**JEFFERSON COUNTY, TEXAS
PURCHASING DEPARTMENT**

ADDENDUM TO IFB

IFB Number: IFB 17-009/JW
IFB Title: Jefferson County Sheriff’s Office Hangar Building
at Jack Brooks Regional Airport
IFB Due: **11:00 am, Tuesday, April 25, 2017**
Addendum No.: 2
Issued (Date): April 11, 2017

01 JCSO HANGAR BUILDING EXISTING NATURAL GRADE PLAN

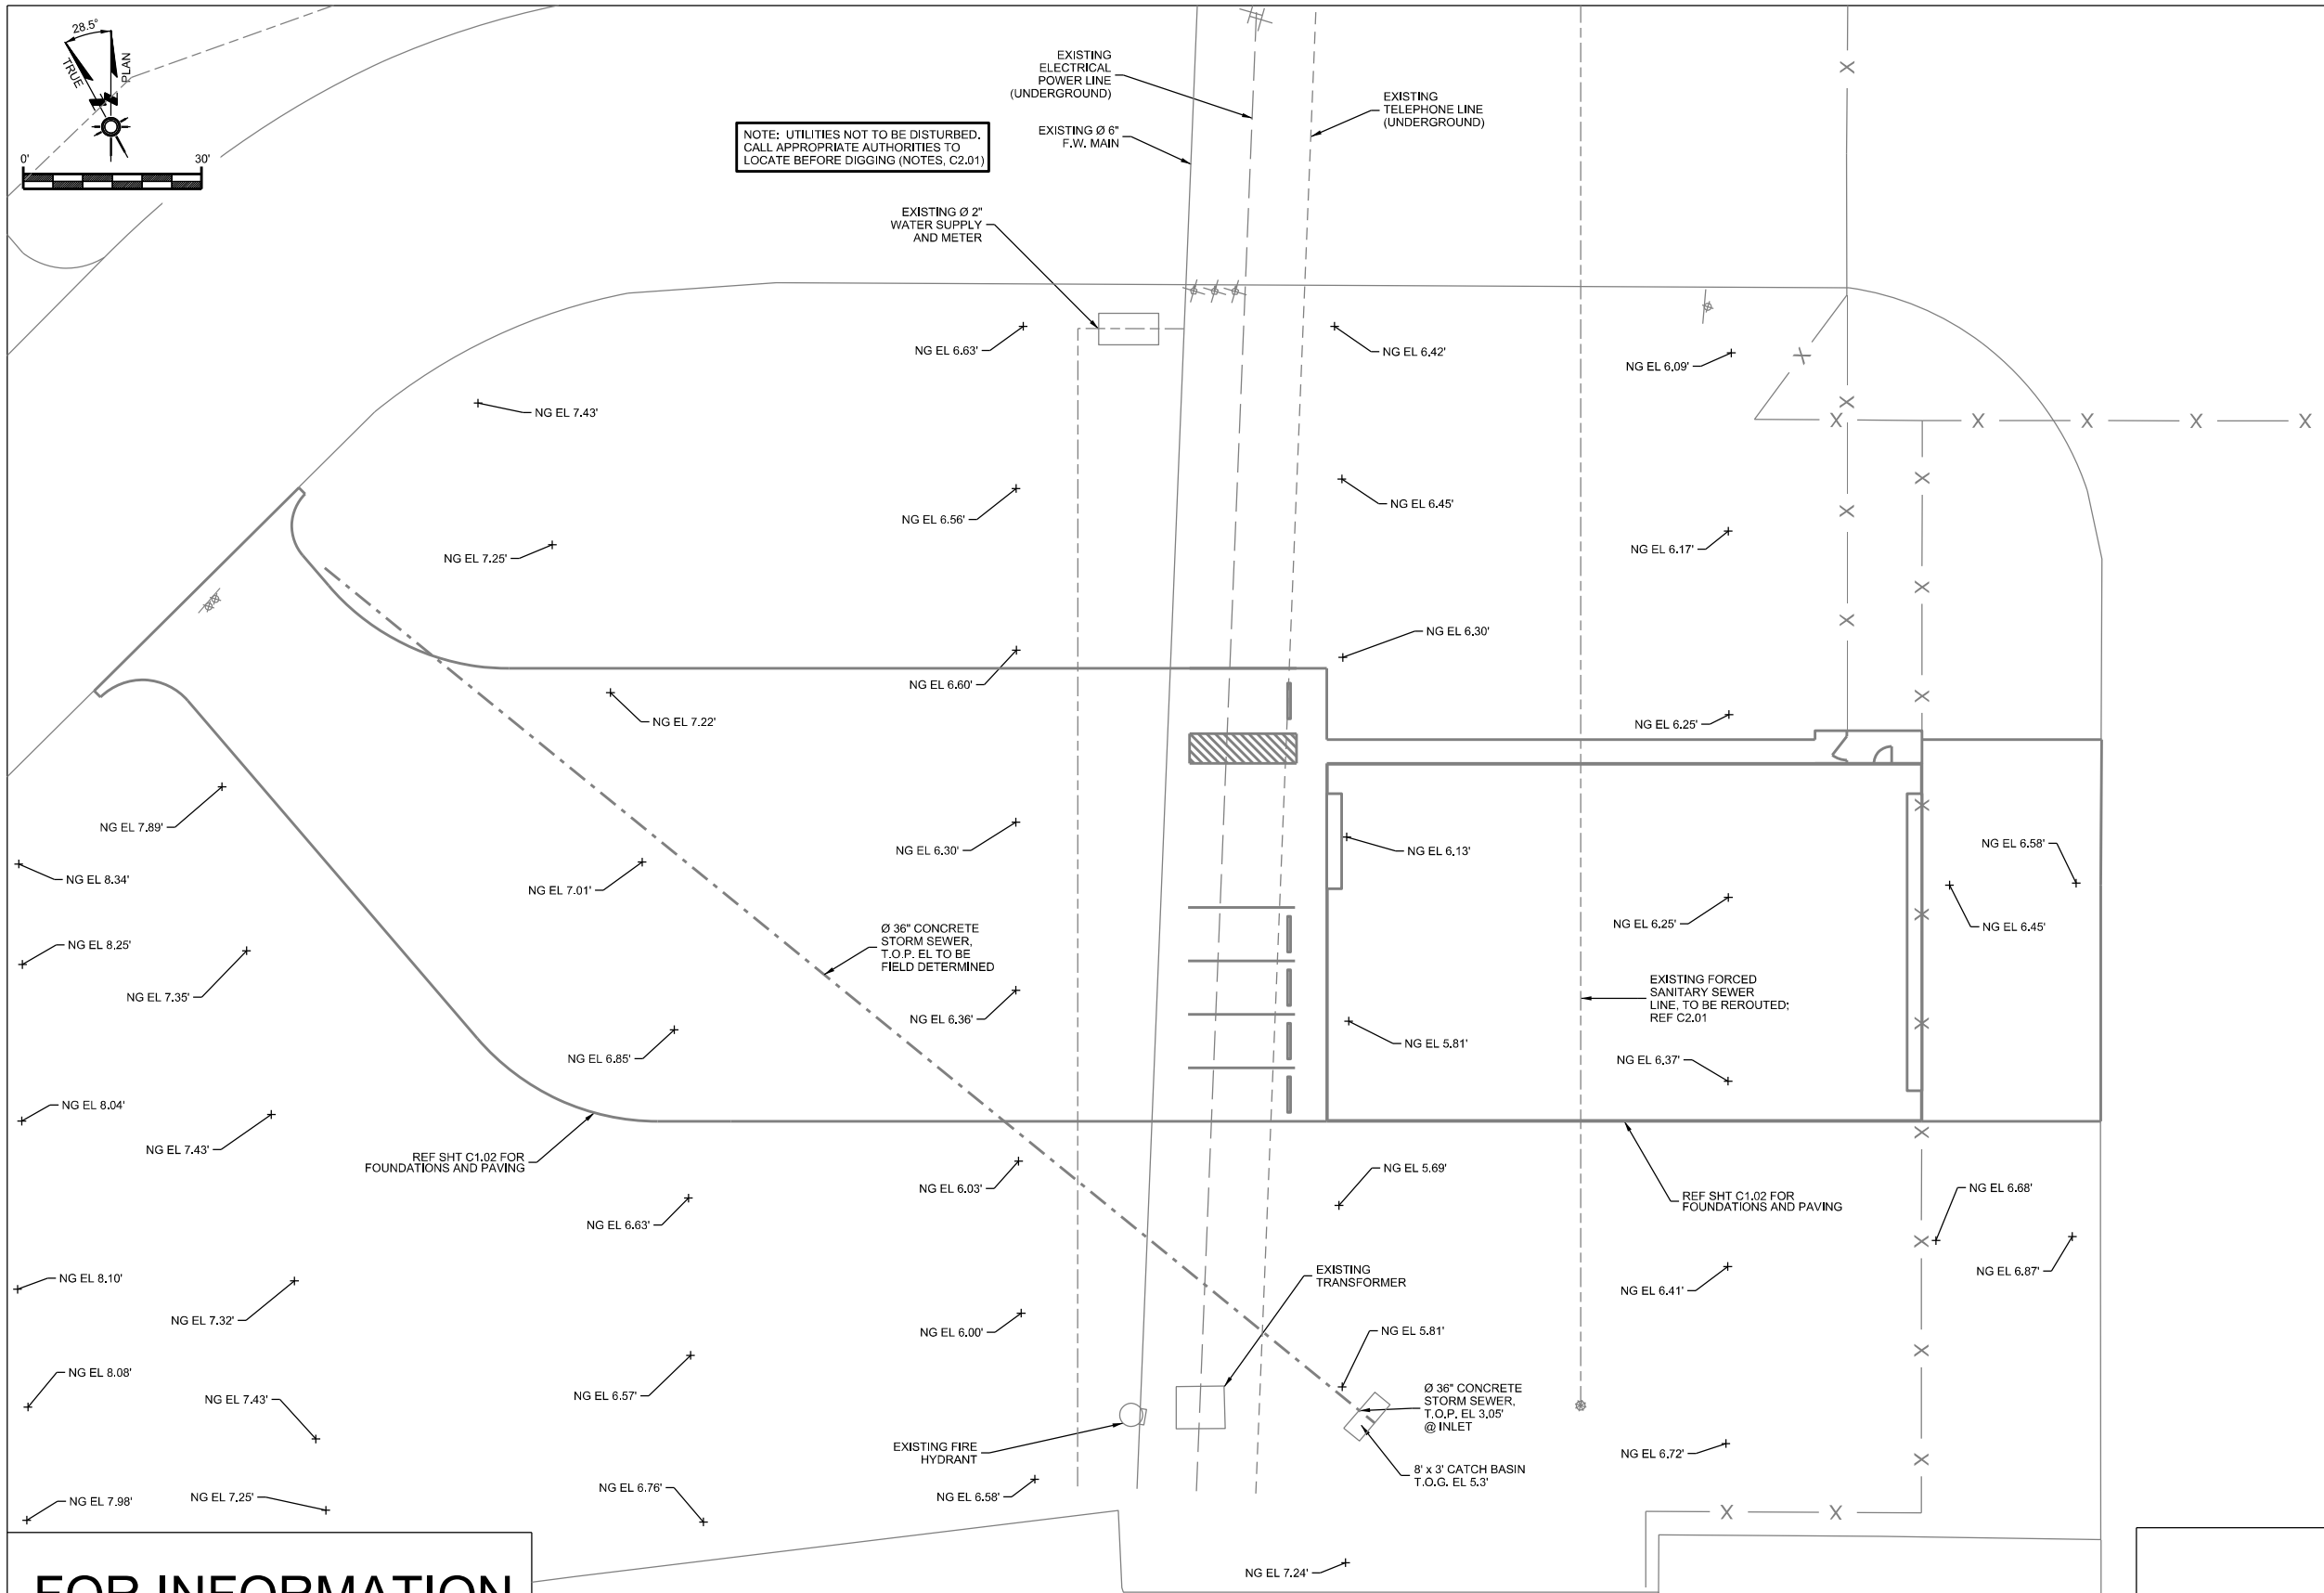
1. Question: The C sheets mark elevations & we assume desired finish elevations. Can you publish existing elevations for reference of material to be added or removed?

Answer: See attached C1.08 added to show current site grade elevations.
